PIC32MM0256GPM064 Family Silicon Errata and Data Sheet Clarification

The PIC32MM0256GPM064 family devices that you have received conform functionally to the current Device Data Sheet (DS60001387D), except for the anomalies described in this document.

The following typographic corrections and clarifications are to be noted for the latest version of the device data sheet (DS60001387D):

2. Module: Pin Diagrams: 48-Pin UQFN, TQFP

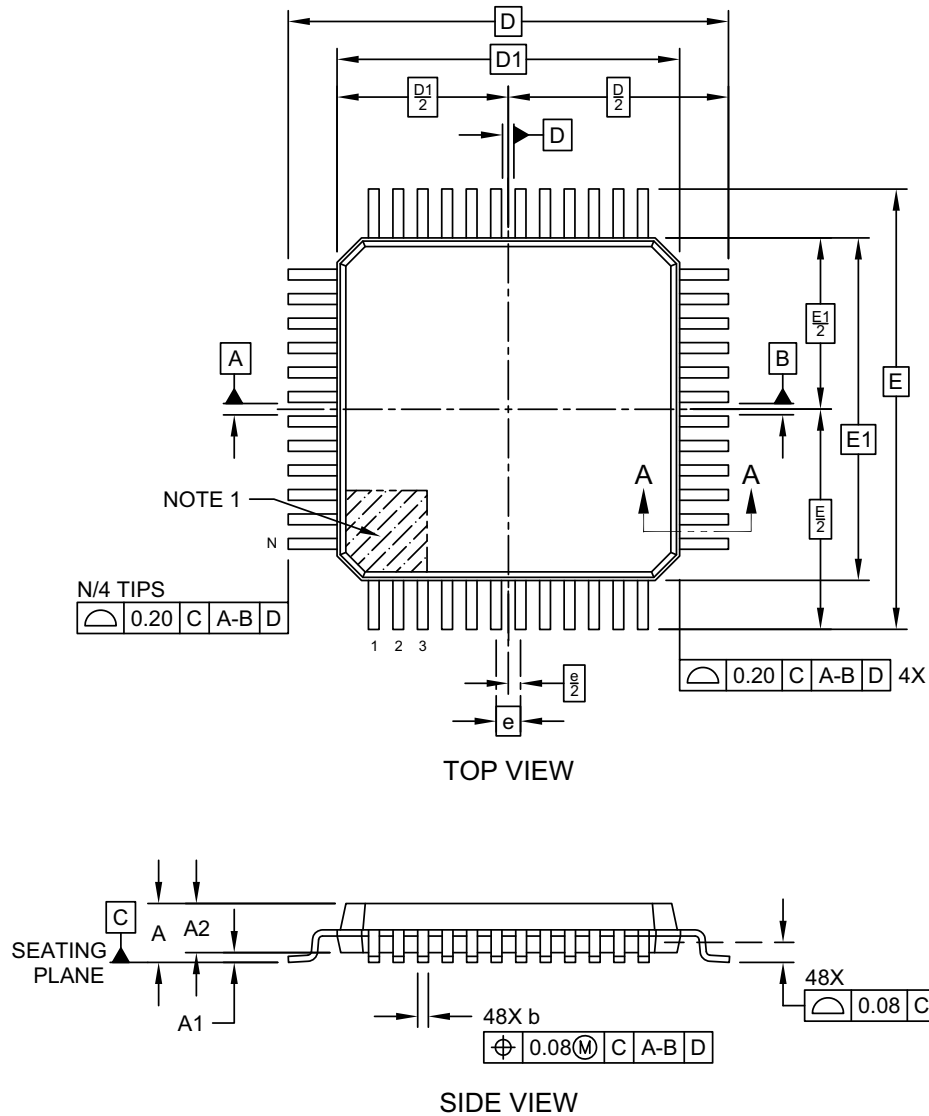
Note 3 is applicable for the 48-pin UQFN package only. The Thermal pad is not available on the 48-pin TQFP Package.

48-Lead Plastic Thin Quad Flatpack (Y8X) - 7x7x1.0 mm Body [TQFP]

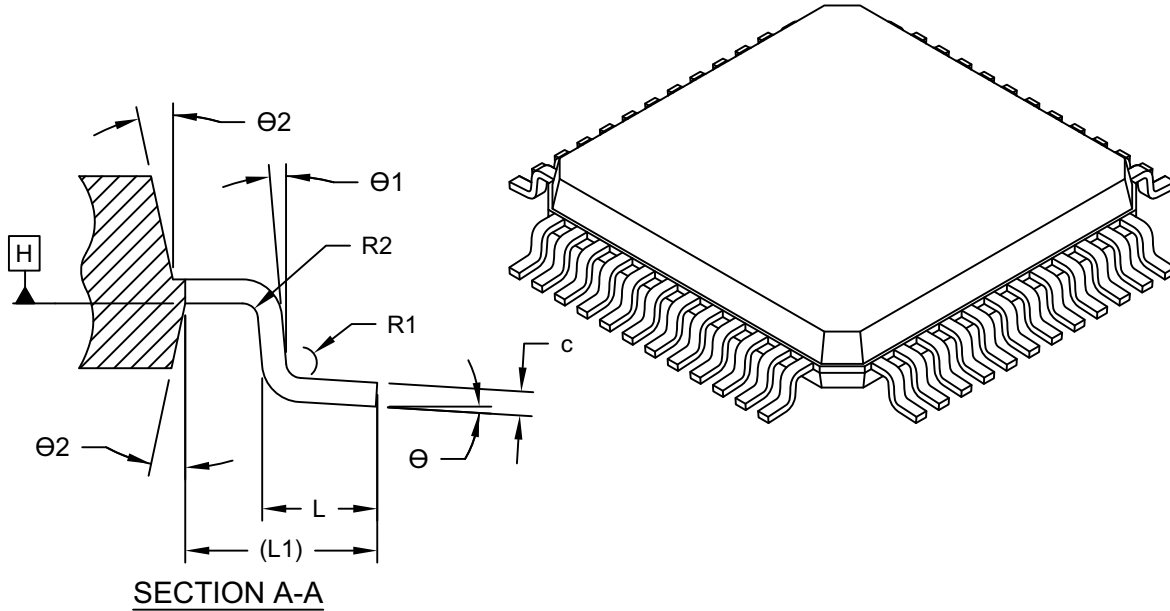
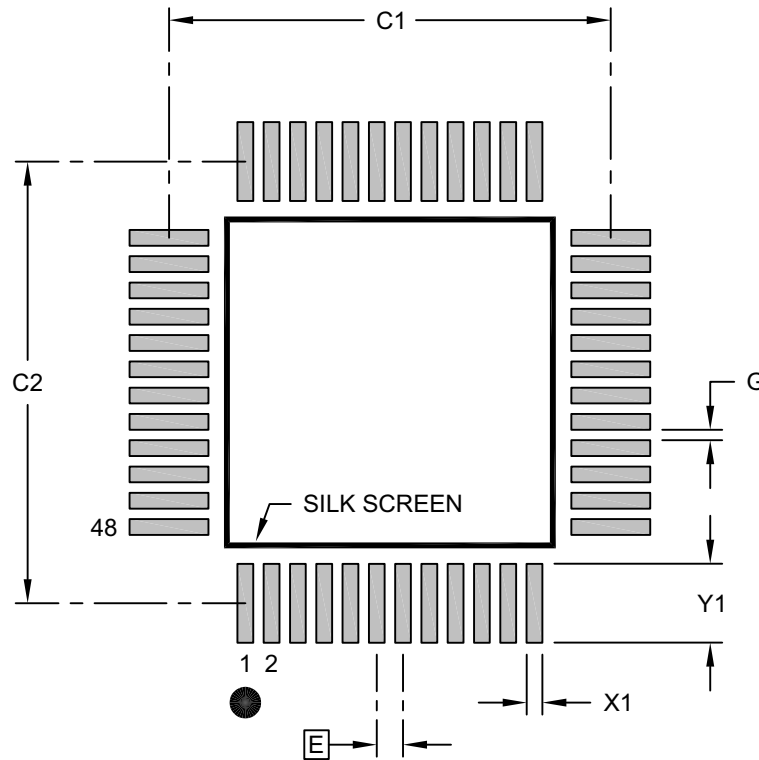
3. Module: Package Details/Drawing: 48-Pin TQFP

The following figure shows the updated package drawing for the 48-Pin TQFP Device:

4. Module: Pin Diagrams: 64-Pin QFN, TQFP

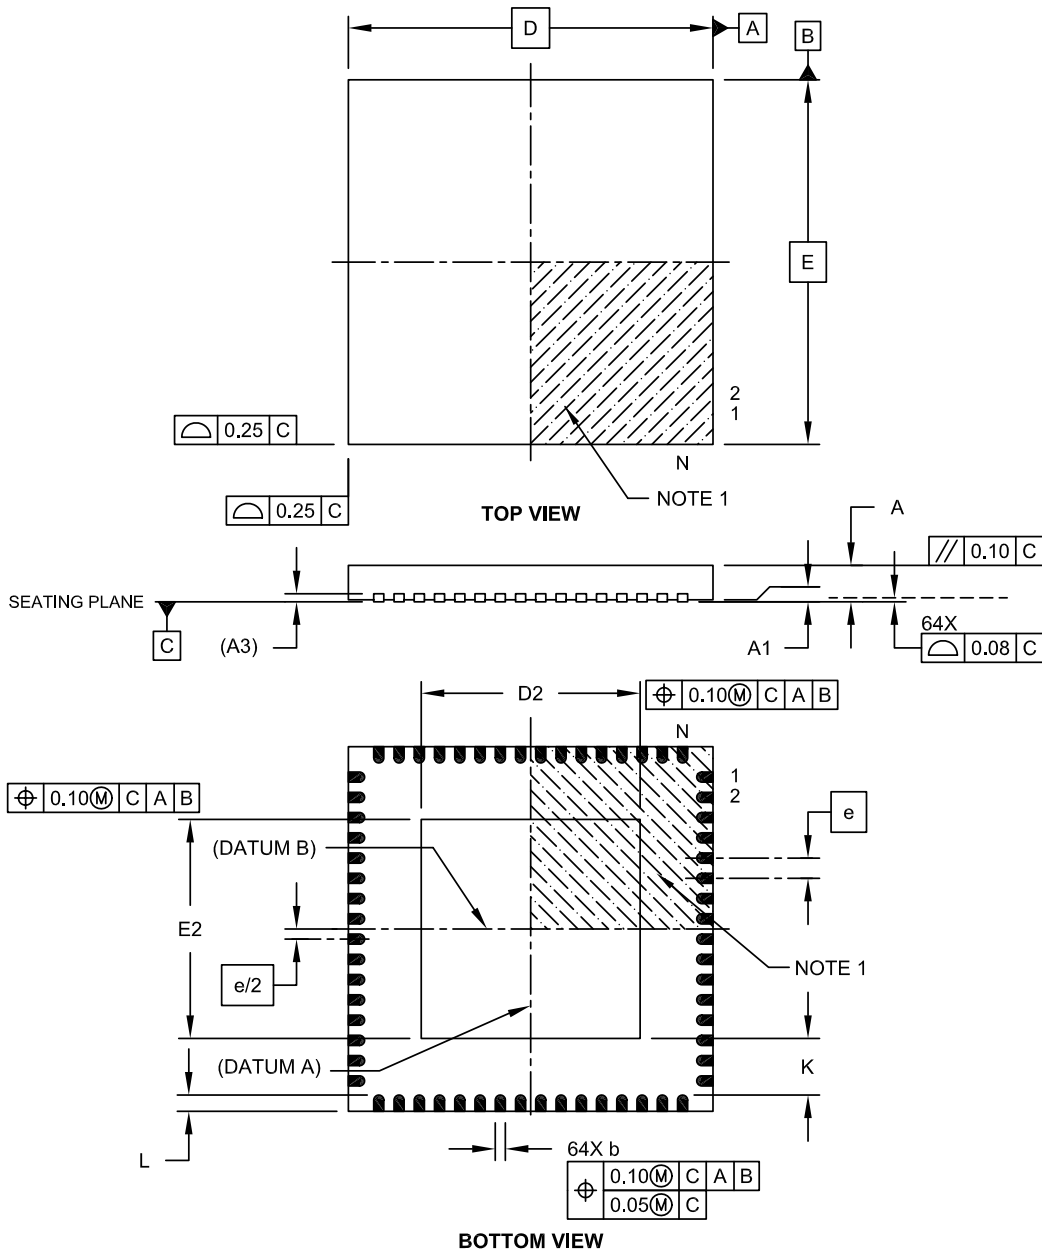
Note 3 is applicable for the 64-pin QFN package only. The Thermal pad is not available on the 64-Pin TQFP package.

64-Lead Plastic Quad Flat, No Lead Package (MR) – 9x9x0.9 mm Body with 5.40 x 5.40 Exposed Pad [QFN]

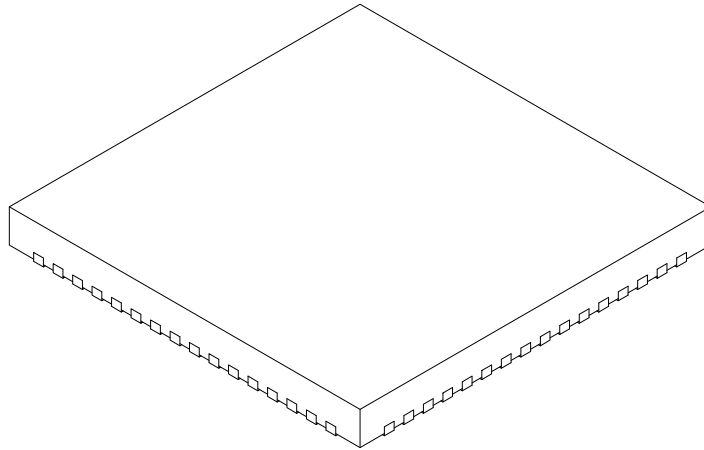
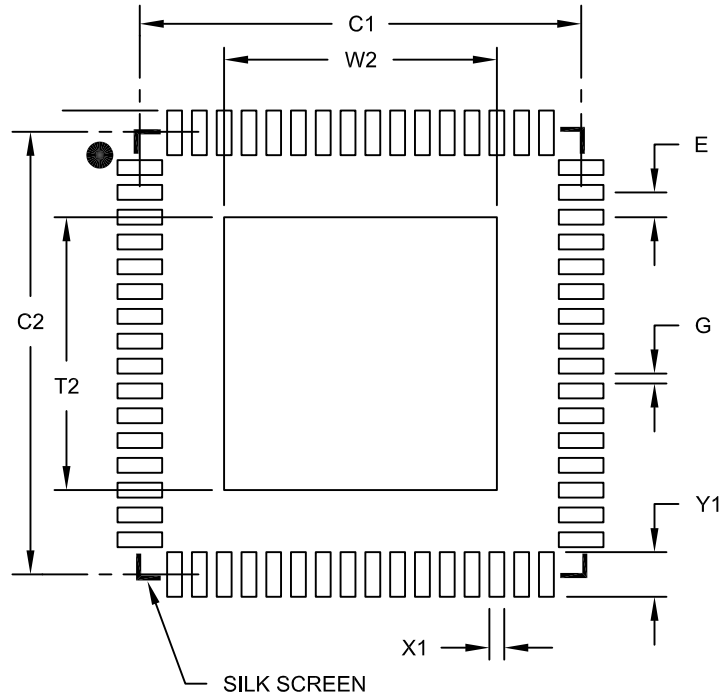
5. Module: Package Details/Drawing: 64-Pin QFN

The following figure shows the updated package drawing for the 64-Pin QFN device.
